Lowdham Roundabout Improvements

**Road Safety Audit
Stage 1 - Completion of Preliminary Design**

SA2222B
June 2020

Stage 1 Road Safety Audit

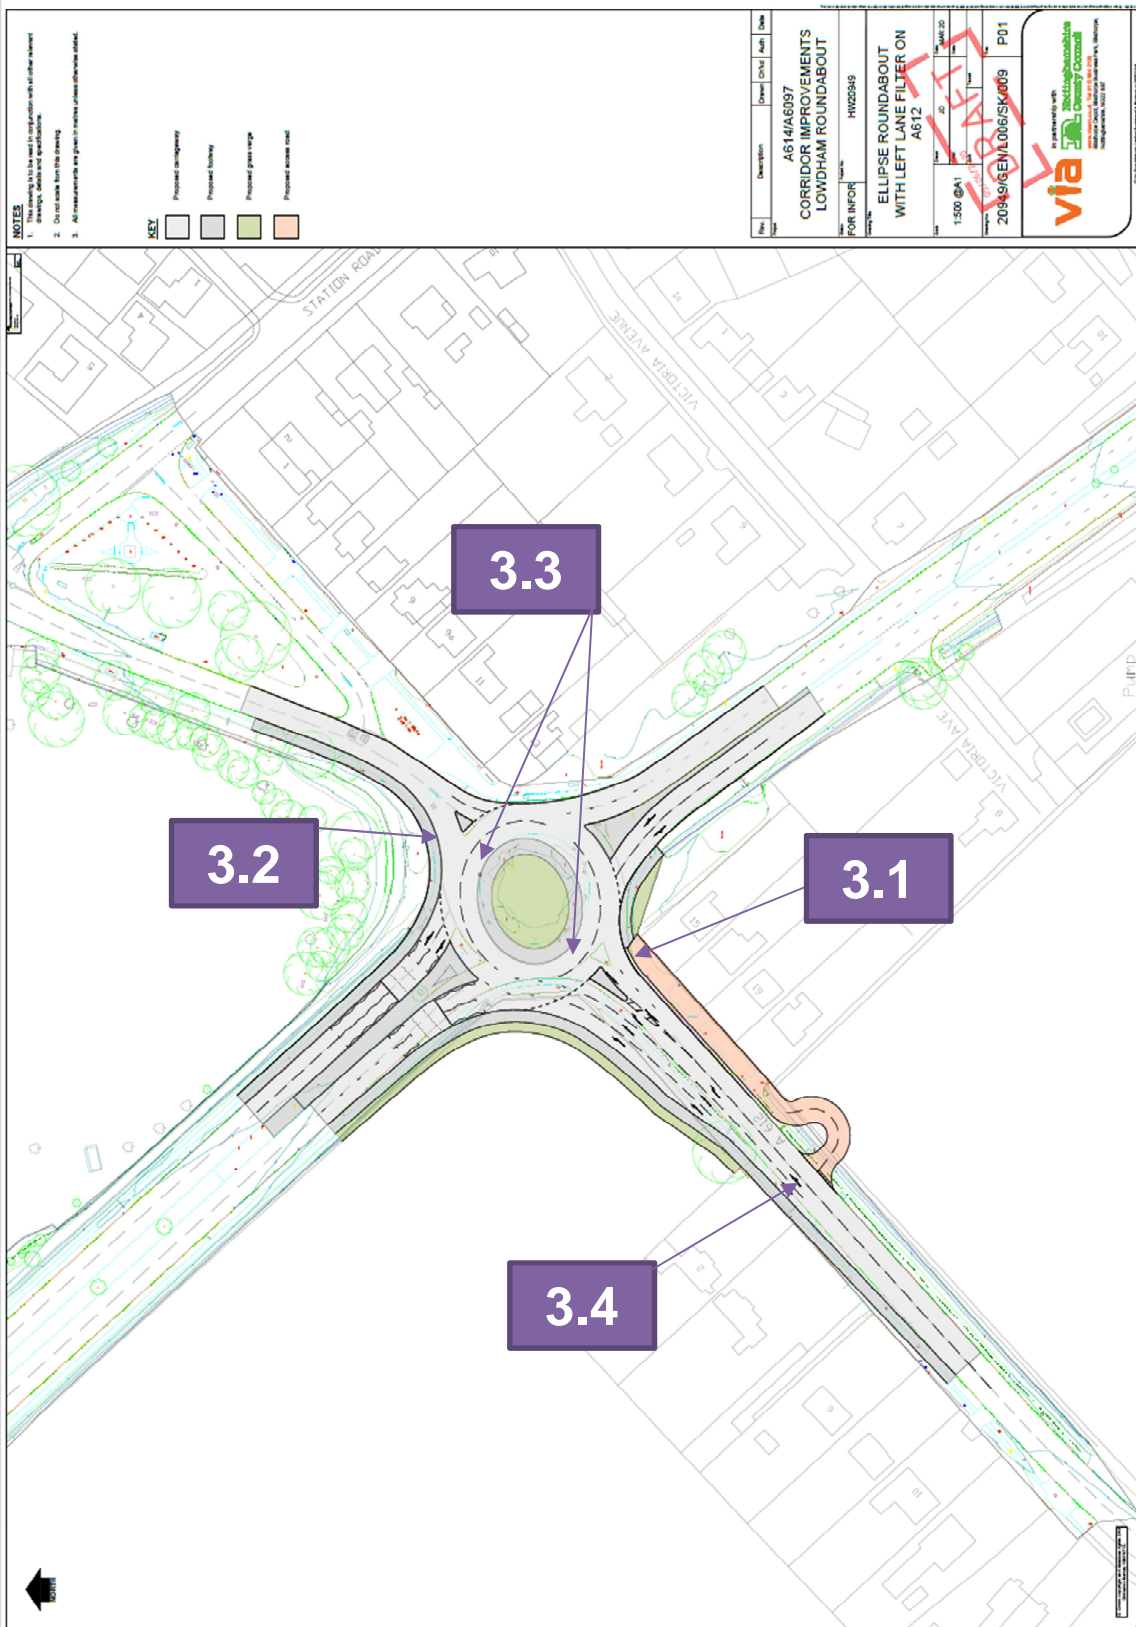
Location: 3.1 – A612 westbound exit from the roundabout.

Summary: Side swipe collisions or head on collisions with opposing traffic.

There are two lanes shown on the A612 WB exit from the roundabout with a very short merge. Drivers of vehicles in the offside lane who try and merge at the end of the two lanes may collide with vehicles in the nearside lane or may collide head on with opposing vehicles, or those waiting to turn right into the service road. Vehicle occupants could be injured.

Location: 3.2 – A612 eastbound exit from the roundabout.

Summary: Side swipe collisions at roundabout exit.

All the roundabout entries have 2 ahead lanes and all the exits have 2 lanes, except for the A612 eastbound. Drivers on the A612 eastbound may mistakenly travel ahead in the offside right turn lane, side swipe collisions could occur with vehicles in the nearside lane if they try and exit the roundabout at the same time, as there is only one lane on the exit. This is likely to become more of a problem as the road markings become worn.

Location: 3.3 – Tighter parts of roundabout.

Summary: Vehicle loss of control due to sharp radii on roundabout causing side swipe accidents.

The proposed roundabout isn't round which means at points of the oval shape the angle tightens which doesn't allow a smooth transition. Drivers will have to adjust their steering wheel mid manoeuvre which can catch drivers out especially when negotiating at speed. A driver could lose control of the vehicle which could lead to hitting another object on or off the carriageway. A more common scenario is a driver just doesn't get their vehicle into lane due to the unusual shape and enters another lane causing a side swipe accident with another vehicle. With this being a route heavily used by HGVs large vehicles will find it the most difficult and could enter more than one lane regularly. Any collision between vehicles could lead to accidents for vehicle occupants.

Location: 3.4 – Private service road.

Summary: Turning right in right turn could be seen as for roundabout and be shunted.

In order to get three lanes on the SW entry arm (Burton Joyce) the lane widening occurs before the new service road with lane markings added where vehicles would need to turn right into the service road. This could cause confusion for drivers following a vehicle ahead intending to turn into the service road. It could look to the following driver as though the vehicle ahead is intending to turn right at the roundabout. When the right turner stops the vehicle being could shunt them causing injury to vehicle occupants.

Capacity over safety will be required in the decision process but does this arm need 2 lanes capacity from Lowdham towards Burton Joyce. If this merge is only being provided for the Entry Arm on Lowdham side of A612 it should be removed. This entry arm could be signed for Left turn only (n/s) and ahead/right (o/s) so that two vehicle merge on the opposing arm is removed.

At detailed design add hatch lines on this exit to strengthen that it is a single lane.

A standard round roundabout would be the safest option. If this oval option is pursued, then it should be shown at stage 2 RSA that vehicles can circulate within their own lanes. The road surface should be brought up to a very good level of grip and maintained regularly to help any loss of control incidents. This could be frequent due to the level of HGV polishing of the road surface.

The service road should join the main road at a point past the lane divergence. Another potential option could be to have a left turn in only at the service road forcing drivers to circulate the roundabout rather than turn right. This is not likely going to be wanted by the residents and the left turn in needs to be made strong with kerb lines and physical restriction such as a splitter island so that drivers aren't tempted to disregard a right turn ban.
